Record of Executive Business and Chief Executive's Order

Reg. Reference:SD22B/0025Application Date:24-Jan-2022Submission Type:AdditionalRegistration Date:26-May-2022

Proposed Development: Single and 2 storey extension to the rear; new front

Location: 13, Ballyboden Crescent, Dublin 16

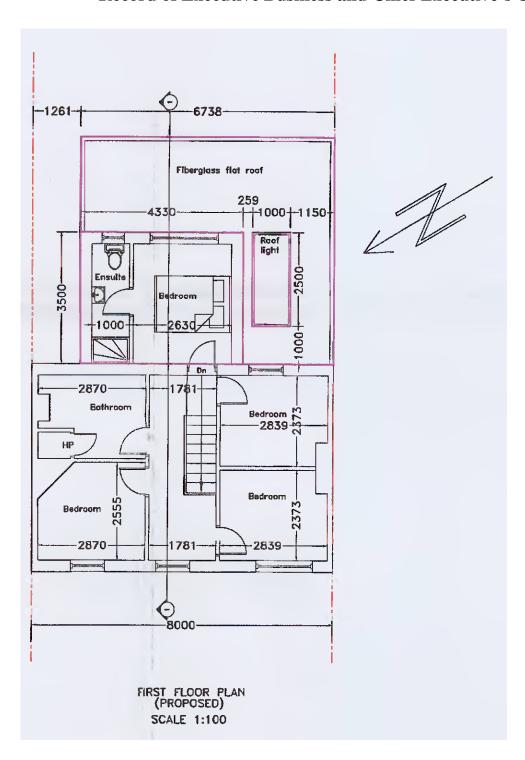
Item 1: First Floor Extension.

1. The plans have been changed to incorporate a new design whereby the rear extension will be single storey at ground level where it borders 14 Ballyboden Crescent to the south. The original concern regarding overshadowing and overlooking on the adjoining has been addressed by the revised plans. The first floor rear extension will be set back from No.14 by a distance of 2.15m.

The revised changes made to the proposed development would address concerns regarding overlooking on the adjoining property. The Planning Authority considers the applicant has satisfactorily responded to the request for additional information for this item.
